Serial: RNP-RA/15-0016
APR 24 2016

H. B. ROBINSON STEAM ELECTRIC PLANT, UNIT NO. 2
DOCKET NO. 50-261 / RENEWED LICENSE NO. DPR-23

APPLICATION FOR TECHNICAL SPECIFICATION CHANGE TO ADOPT TECHNICAL SPECIFICATIONS TASK FORCE (TSTF)-339, RELOCATE TS PARAMETERS TO THE COLR CONSISTENT WITH WCAP-14483, REVISION 2

Figure 2.1.1-1 (page 1 of 1)
Reactor Core Safety Limits

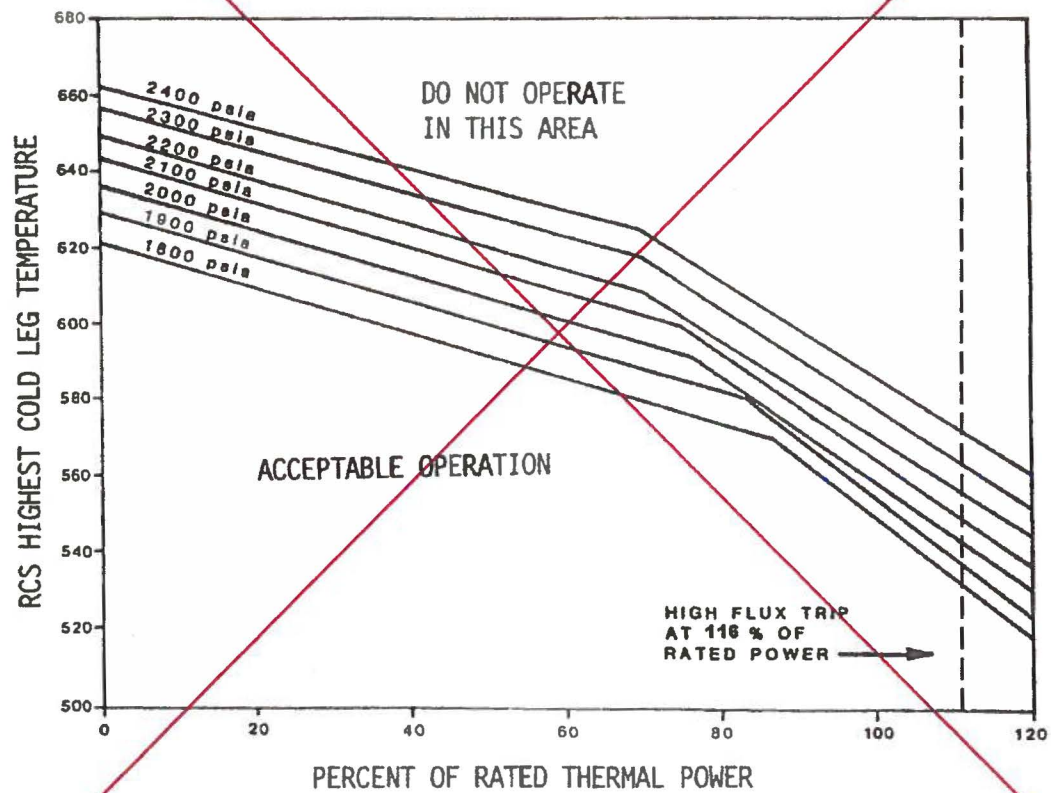
The proposed amendment would relocate TS Figure 2.1.1-1, "Reactor Core Safety Limits," to the COLR, replacing it with more specific requirements regarding the safety limits (i.e. fuel DNB design basis and the fuel centerline melt design basis) conforming with WCAP-14483-A. As discussed in the Safety Evaluation Reports to Westinghouse Topical Report, WCAP-14483-A, it is necessary to relocate TS Figure 2.1.1-1 to the COLR since cycle-dependent changes to parameters upon which TS Figure 2.1.1-1 is based would require a license amendment request to revise the figure.

DELETED
Figure 2.1.1-1

INSERT #1

the COLR; and the following SLs shall not be exceeded:

2.1.1.1 The departure from nucleate boiling ratio (DNBR) shall be maintained ≥ 1.141 for the HTP correlation and ≥ 1.17 for the XNB correlation.

2.1.1.2 The peak fuel centerline temperature shall be maintained $< [(2790 - 17.9 \times P - 3.2 \times B) \times 1.8 + 32]$ °F where P is the maximum weight percent of Gadolinia (%) and B is the maximum pin burnup (GWD/MTU).
